Device	TC1762
Marking/Step	EES-AA, ES-AA, AA
Package	PG-LQFP-176-2

01742AERRA

This Errata Sheet describes the deviations from the current user documentation.

Figure 2 Timing concerning equidistant multiple timers

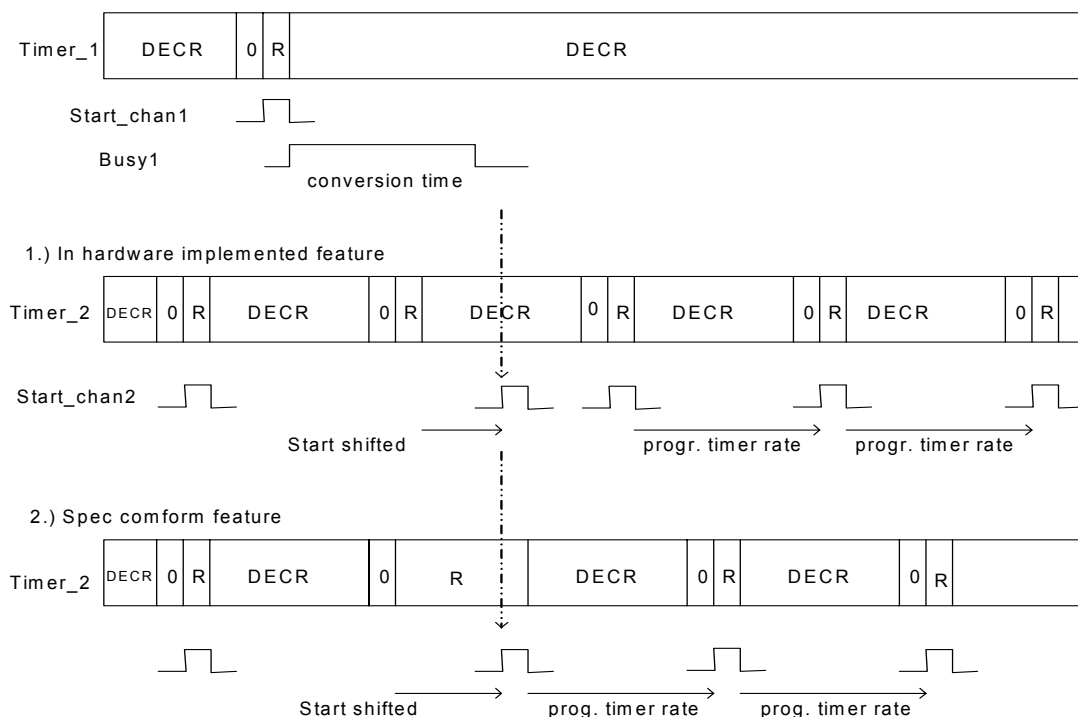
`Timer_1` becomes zero and starts a conversion. `Timer_2` becomes zero during this conversion is running and sets the conversion-request-bit of `channel_2`. At the end of the conversion for `channel_1` this request initiates a start for `channel_2`. But the `Timer_2` is reloaded only when setting the request-bit for `channel_2` and is decremented during the conversion of `channel_1`.

The correct behavior would be a reload when the requested conversion (of `channel_2`) is started.

Therefore the start of conversion for `channel_2` is delayed by maximum one conversion-time. After this delay it will be continued with equidistant conversion-starts. Please refer to the following figure.

Figure 3

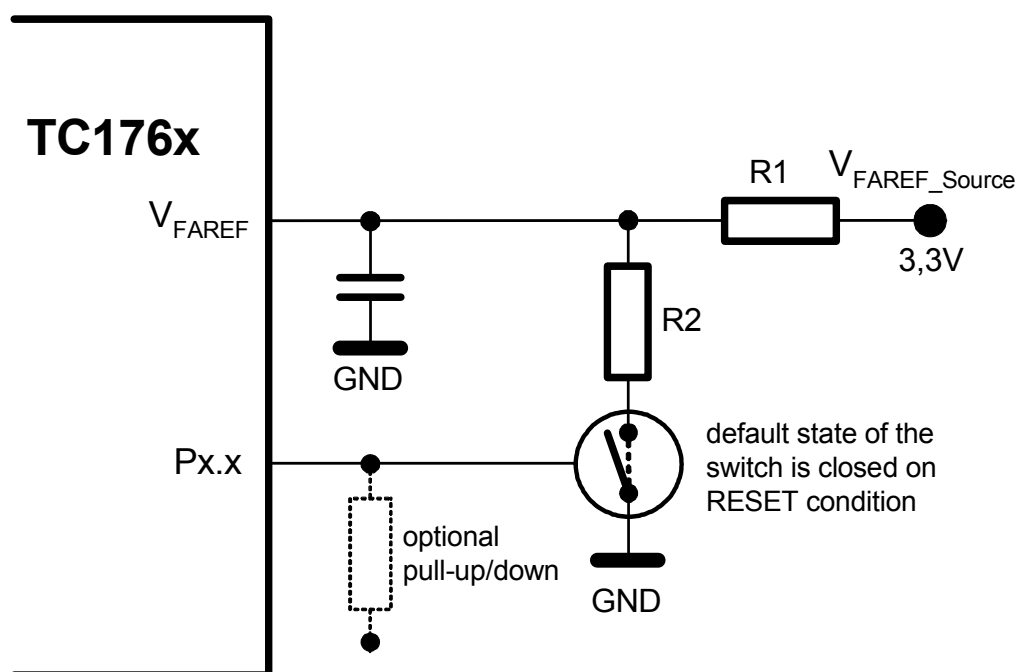
The V_{FAREF} voltage is directly connected via an resistor to the gate of an 1.5 V transistor if the analog part of the FADC is not enabled by setting bit `GCR.ANON` in the FADC.

For V_{FAREF} voltages above 1.65 V this can cause oxide damage in the gate of an 1.5 V transistor which may lead to an increased leakage current at the V_{FAREF} input pin.

Figure 4 **Uncritical transmission**

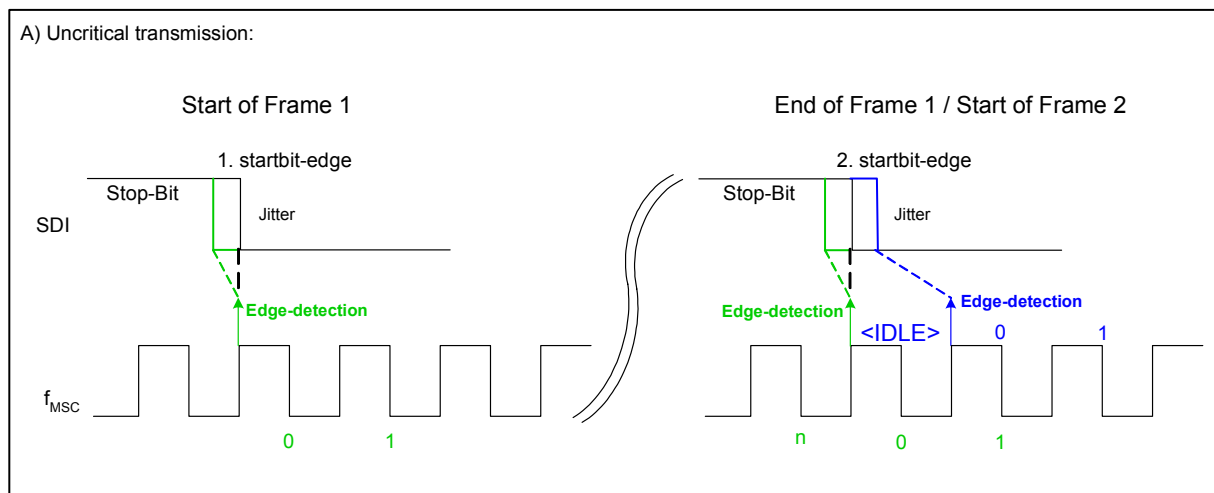
As the falling startbit edge is shifted to the left of the rising clock edge (**Figure 4** left), there occurs a secure detection of the next start-bit edge in the last cycle of the previous frame (here cycle n, **Figure 4** right) independent from the applied jitter to this edge.

Figure 5 **Critical transmission**

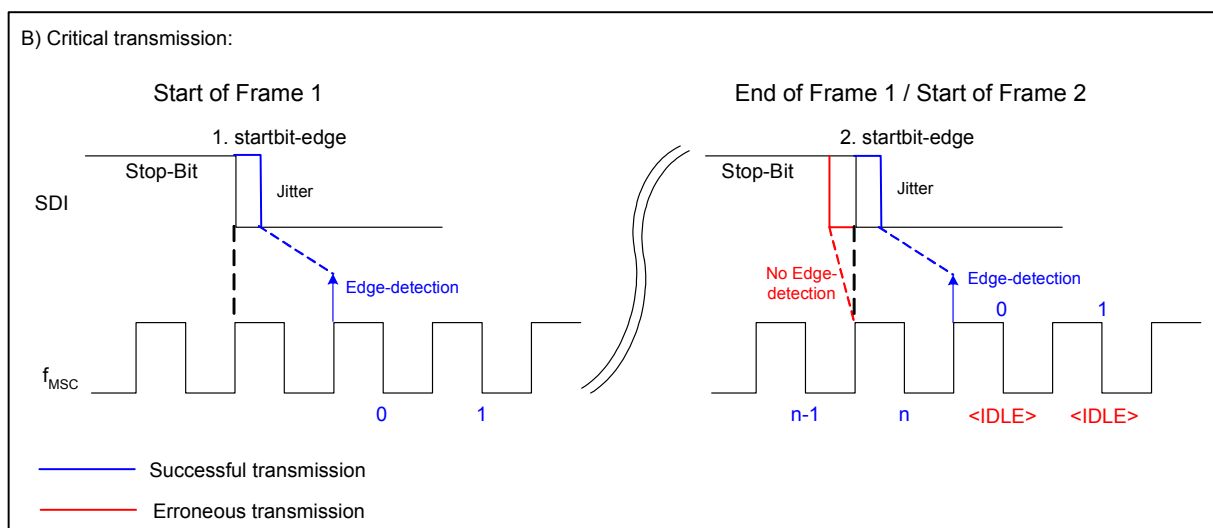
If the high-low edge of the start-bit in the first frame is just not detected by the near clock-edge (**Figure 5** - left) and the start-bit edge of the second frame is jittering to cycle $n-1$ (**Figure 5** - right, red coloured), then an erroneous transmission will take place. In this case the state-machine switches to IDLE after the last state n and wakes up on the next falling edge that may be a data-bit recognized as a start-bit. If the start-bit of the second frame is jittering to cycle n (**Figure 5** - right, blue colored), then the state-machine will not switch to IDLE but will start receiving the next frame correctly.

Figure 10 Current accuracy range

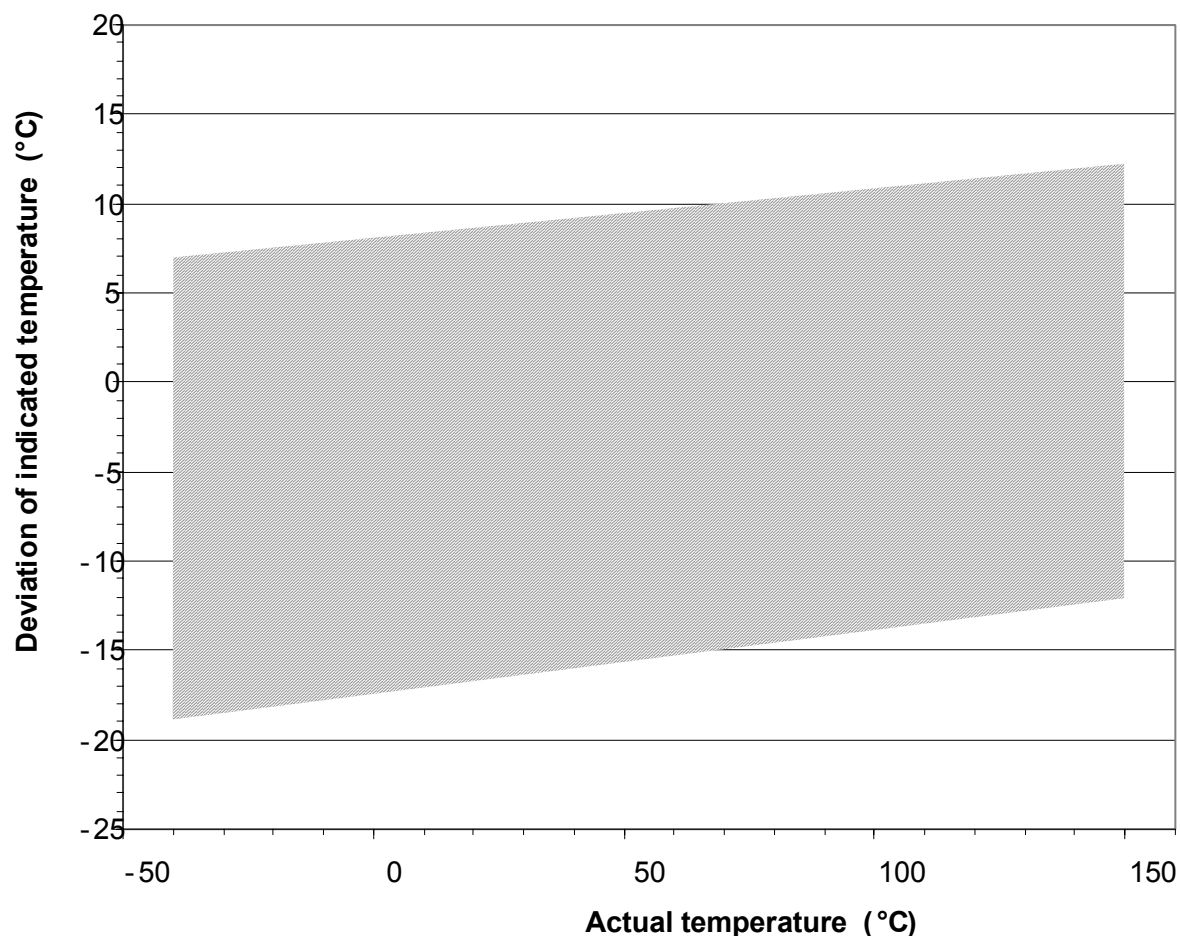
The accuracy of the DTS deviates from the values specified in the Data Sheet. The formulas available on the specification are as follows:

- $\pm 12^{\circ}\text{C}$ at $T_j = 150^{\circ}\text{C}$
- $\pm 9/-17^{\circ}\text{C}$ at $T_j = 25^{\circ}\text{C}$
- $\pm 7/-19^{\circ}\text{C}$ at $T_j = -40^{\circ}\text{C}$

Figure 11 Exemplary power-up/down sequence

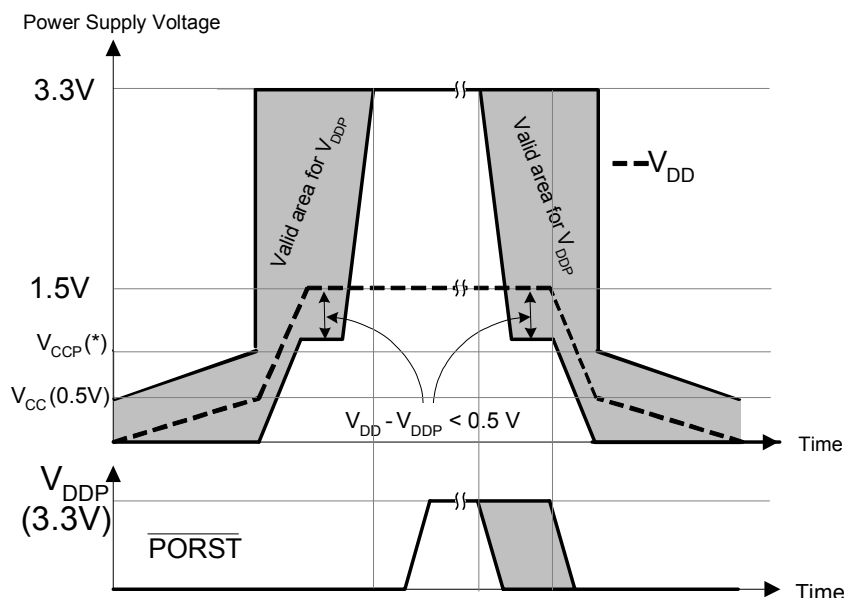
As per Data Sheet, $V_{DD} - V_{DDP} < 0.5\text{ V}$ has to be valid at any time in order to avoid increased latch-up risk. The figure below shows the possible V_{DDP} values as shaded region for an exemplary V_{DD} ramp. Moreover, the following rules apply:

- All analog voltages (V_{DDOSC3} , V_{DDM} , V_{DDMF} , V_{DDFL3}) must also follow V_{DDP} power-up/down sequence.
- V_{DDAF} , V_{DDOSC} must follow V_{DD} power-up/down sequence.
- The absolute value of the maximum allowed deviation between any two supplies is 0.5 V while the 1.5V supplies are below their specified operating conditions.

*Note: V_{CC} and V_{CCP} in [Figure 11](#) refer to devices with *PWR_TC.P009* erratum.*
